APPLICATION FOR PERMISSION
UNDER SECTION 16 OF
THE TOWN PLANNING ORDINANCE
(CAP.131)

For Official Use Only 請勿填寫此欄	Application No. 申請編號	A/SLC/176
	Date Received 收到日期	13 APR 2023

Electricity supply is required by the applicant located at Government Land in DD316L
 San Wai Tsuen, Pui O, Lantau Island. In order to provide new supply to the applicant for
 electric charger and lighting, this scheme is prepared to lay new LV cable as shown in the
 Drawing WELT2022-0159-01 & WELT2022-0159-02. The total trench length(L) x width(W)
 is 37.73m(L) x 1m(W) x 1.2m(D).

**Appendix Ia of RNTPC
Paper No. A/SLC/176**

PLAN REF. : WELT2022-0159-02

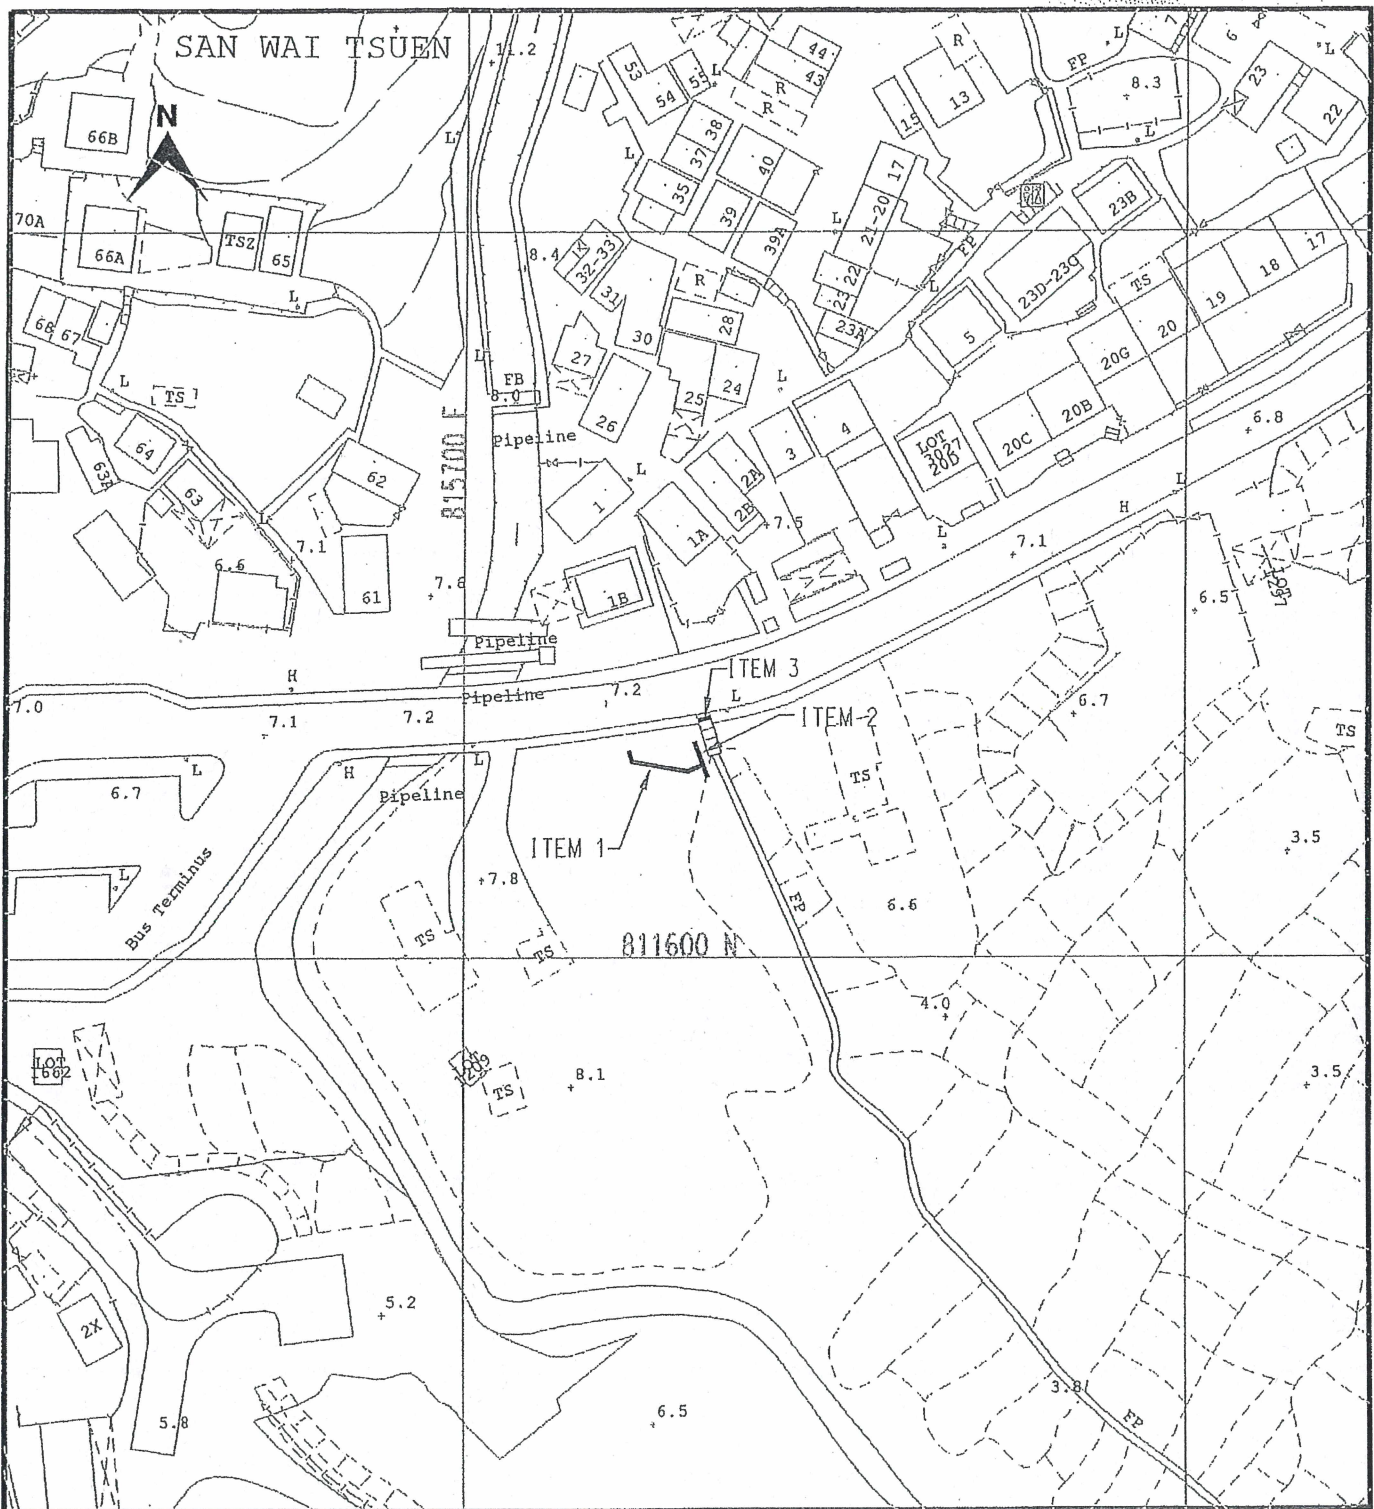
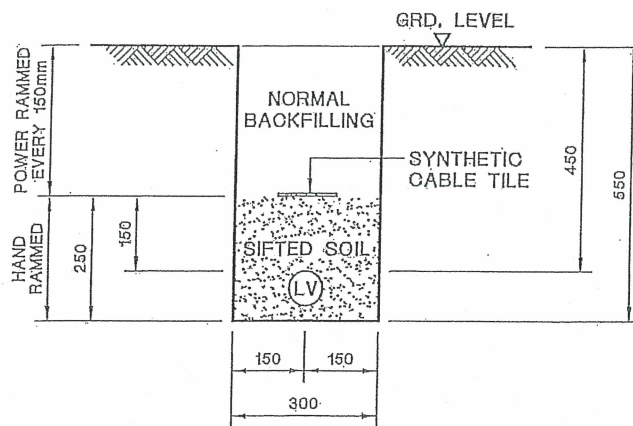
I would like to supersede our previously submitted drawings WELT2021-0159-01 & WELT2021-0159-02 by
WELT2021-0159-03 and also page 6 of the S16 form.
